Clearwater Dam Consensus Report

External Peer Review of DSAC-1 Projects

June 9, 2008

DSAC Class I Dams
Peer Review Panel

Figure 15. Schematic Section through Sinkhole

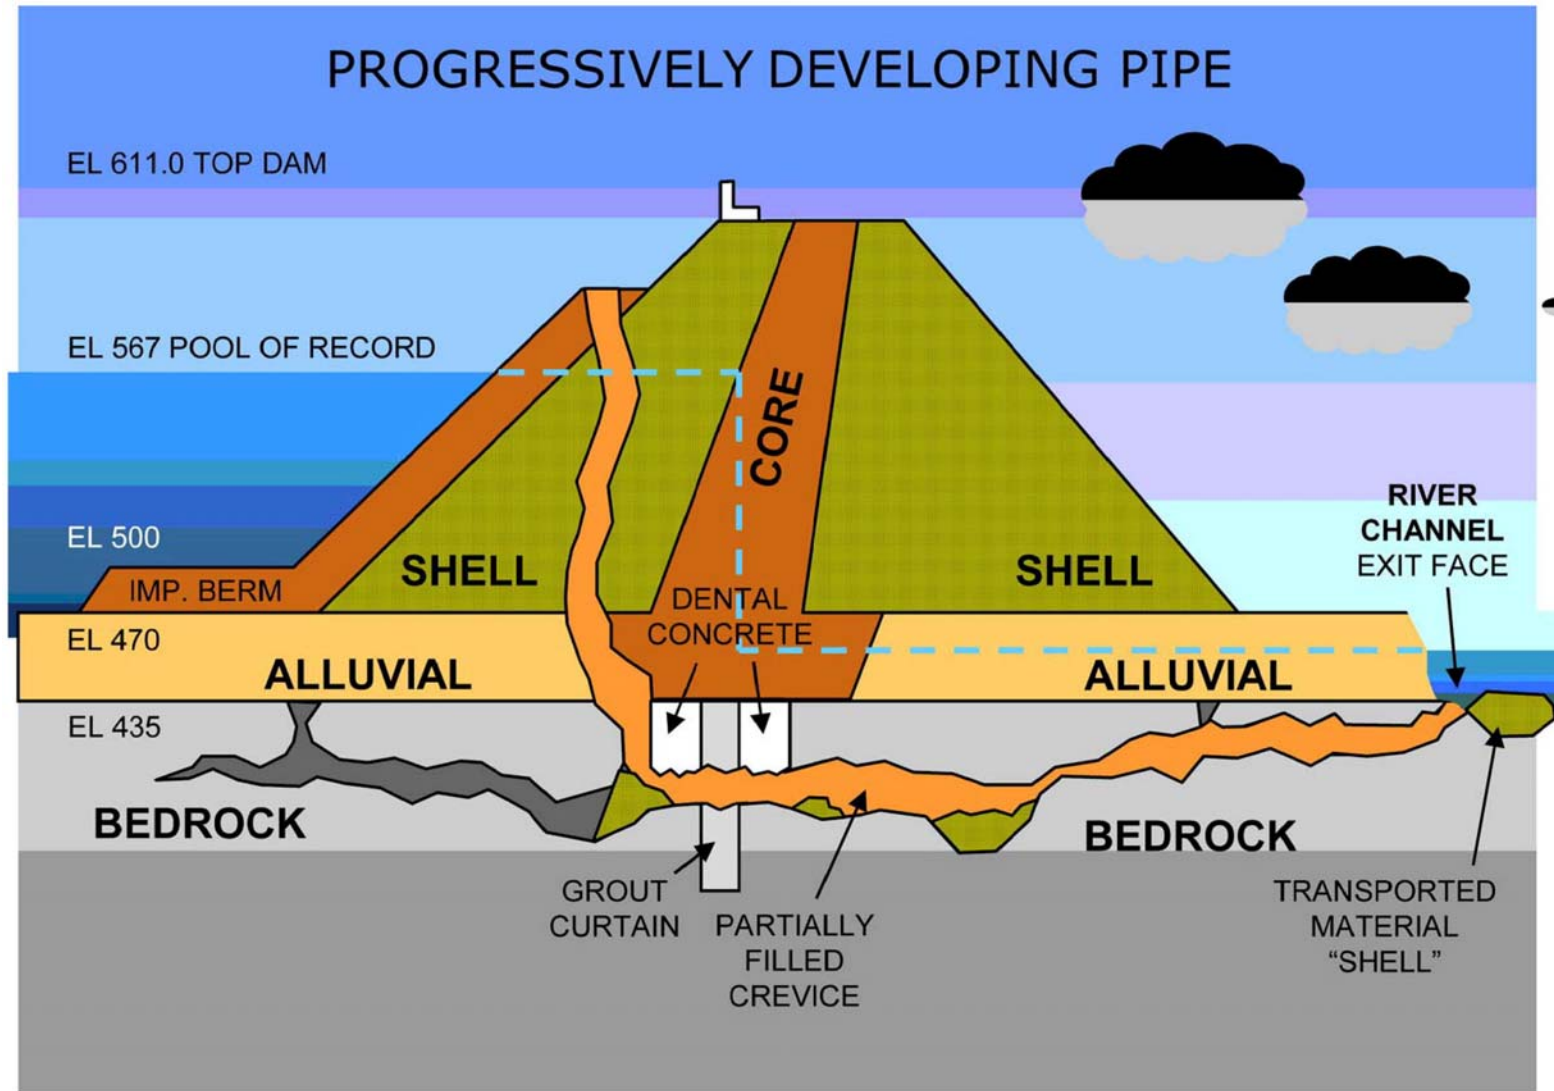
A sinkhole was first observed in January 2003 on the upstream slope at about El. 573, which is above the record pool level, but just below the top of the seepage berm placed in 1988. The hole was near the top of the clay seepage berm and was about 10 feet in diameter and 8 to 10 feet deep. A photograph is shown on Figure 11 of the bottom of the sinkhole after excavation to a depth of 25 feet. At the bottom, the sink hole is about 2 feet in diameter and is filled with the material from above. Figure 12 shows the location of the sinkhole superimposed on two wide joints in the Karst that were found during construction of the cutoff trench. Openings through

one or both of these joints are considered to have allowed the sinkhole to form. Photos of the two joints, taken during construction, are shown on Figures 13 and 14. Figure 15 shows one schematic cross section to demonstrate how the sinkhole may have formed.

Repairs were made by filling the sinkhole with compacted clayey fill. The Panel observed the repaired area during the site visit.

Figure 16. General Continuum to Failure

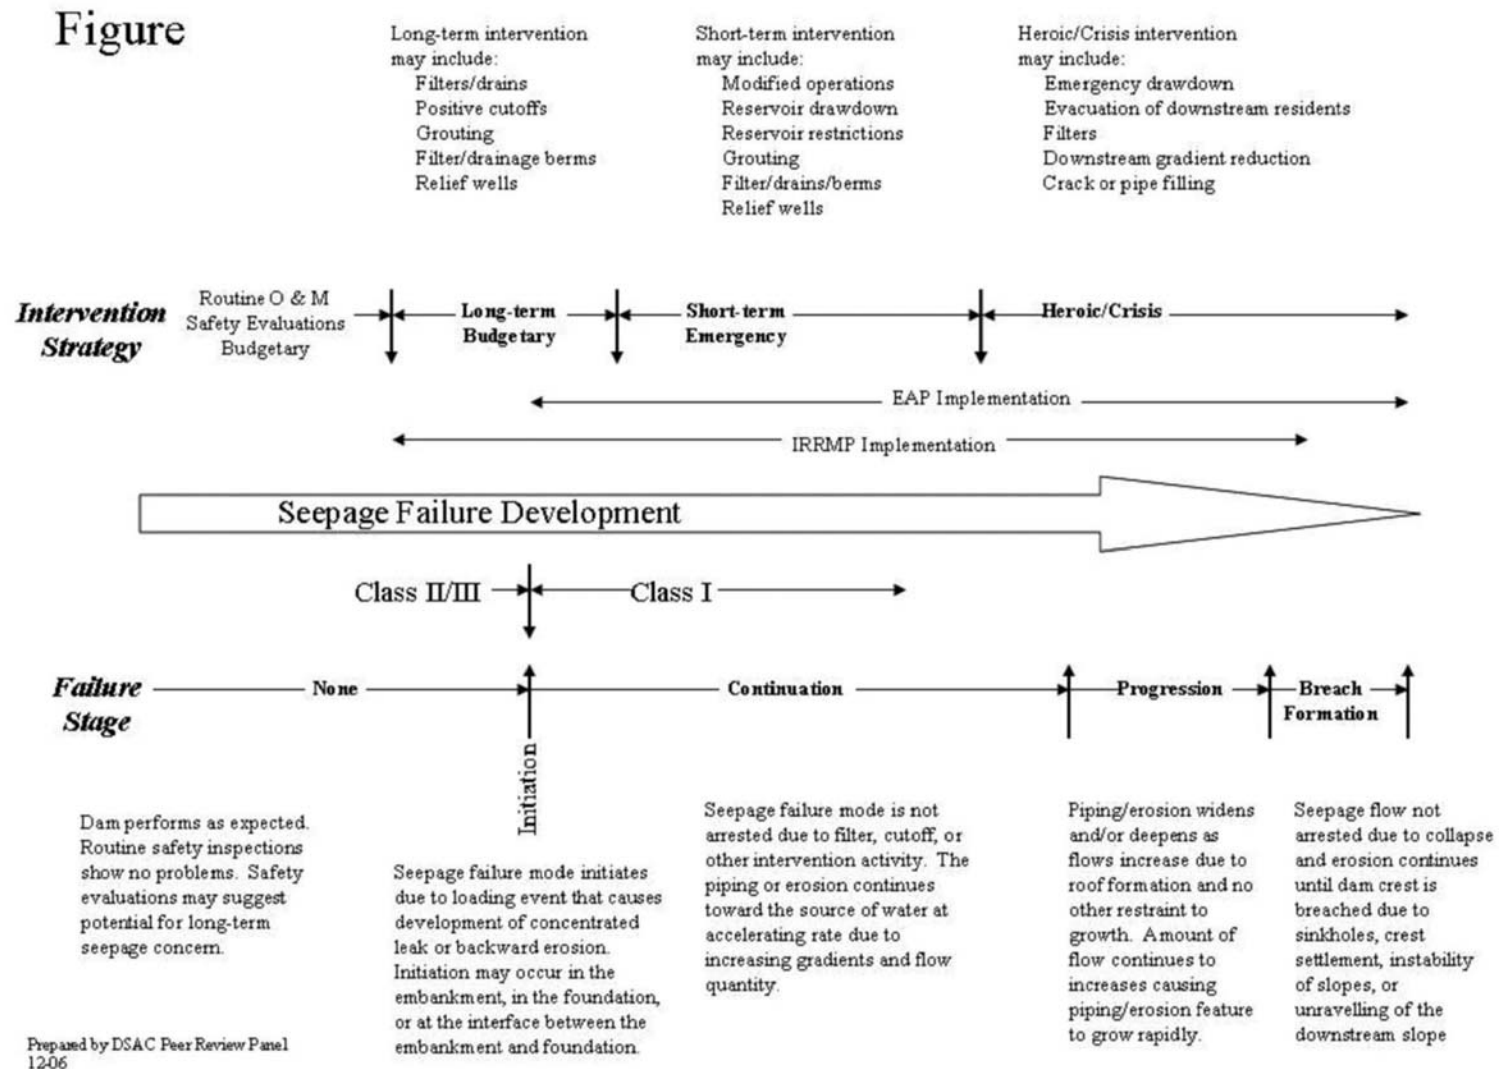
The Panel has developed a graphical depiction of a seepage failure mode continuum and has presented this depiction in a separate memorandum (DSAC Peer Review Panel, December 14, 2006). The failure continuum on Figure 16 summarizes four stages of failure development and three corresponding intervention strategy categories as seepage characteristics progress along the continuum. The various modes of failure are described in Section 5.0.

Figure 17. Clearwater Continuum to Failure

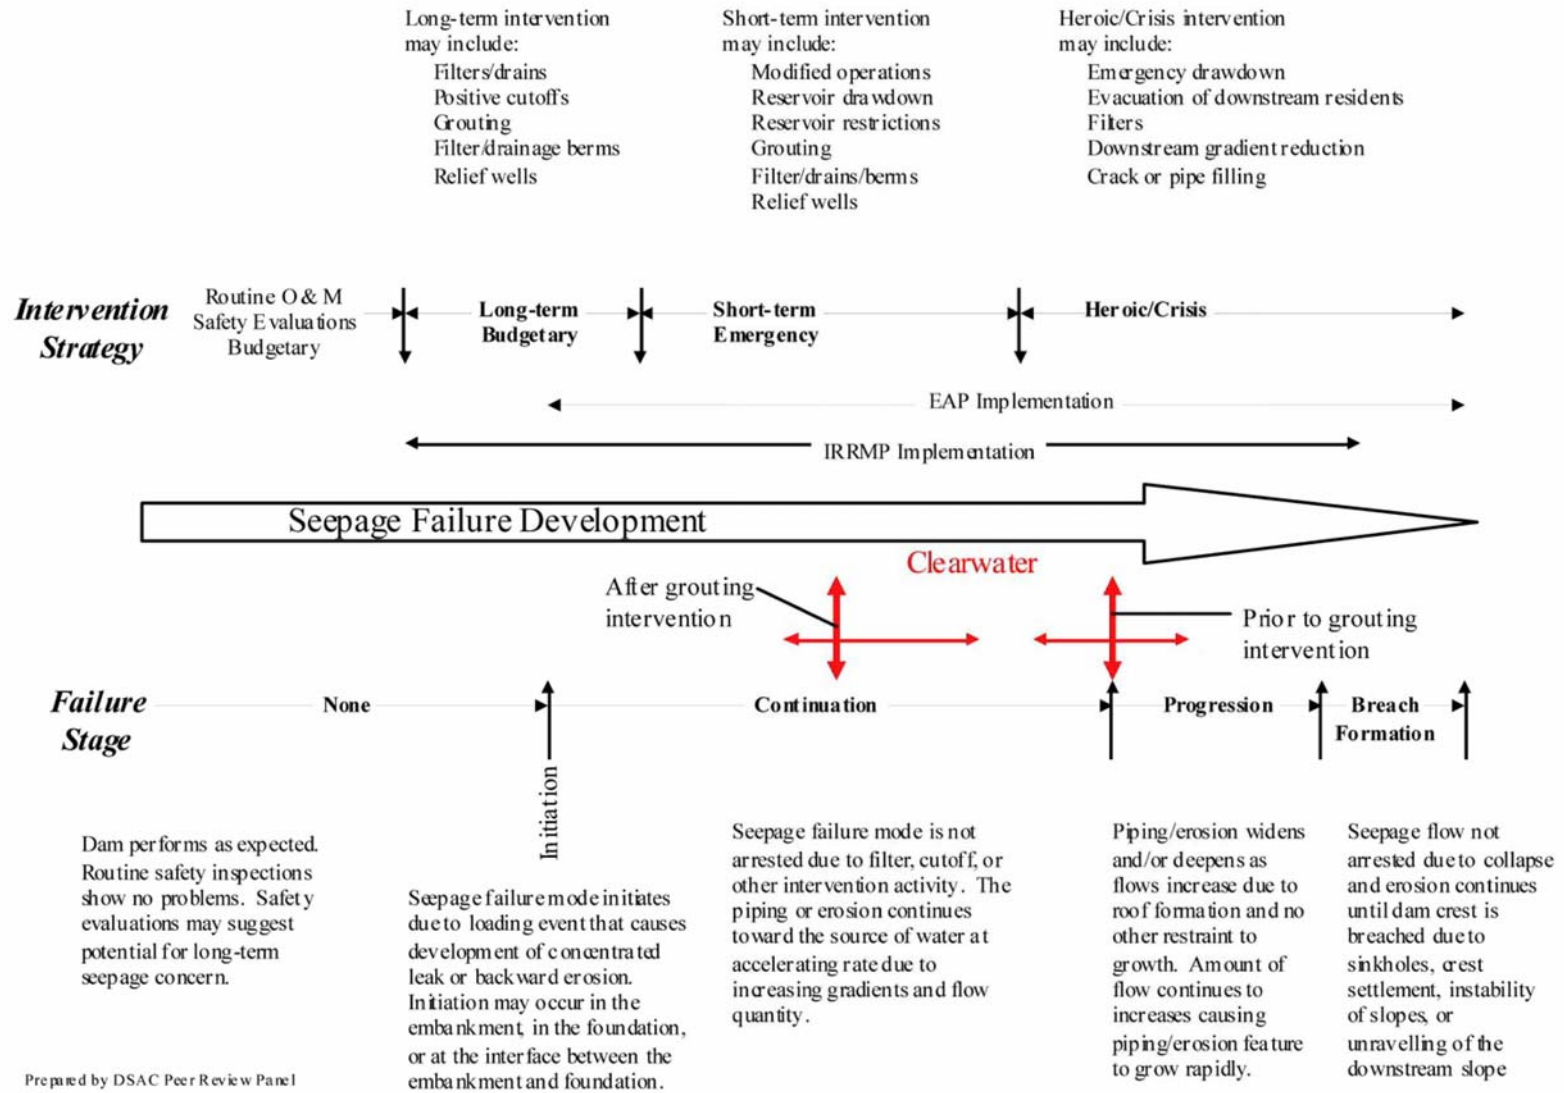
The Panel's assessment of the safety of this dam is shown along the Failure Continuum on Figure 17. Our assessment, as shown in this diagram, indicates that a seepage-related failure mode has initiated. Appearance of the sinkhole on the upstream slope of the dam indicates that the continuation phase has been completed and that the dam is entering the progression stage toward failure. During the progression stage the rate of seepage and piping and the corresponding rate of deterioration will significantly increase whenever the pool rises. The heavy red arrow on the right shows that the dam is susceptible to a seepage failure unless remedial measures are taken.

Upon completion of the planned remedial measures for the seepage and piping failure mode, the probability of a seepage and piping failure will be decreased and the life of the dam will be increased. The red arrow to the left on the Failure Continuum is the Panel's current estimate of the improvement. However, instrumentation will be installed in the dam to better judge the actual improvement.

Variations in Panel member opinions are represented by the confidence bands presented on Figure 17.
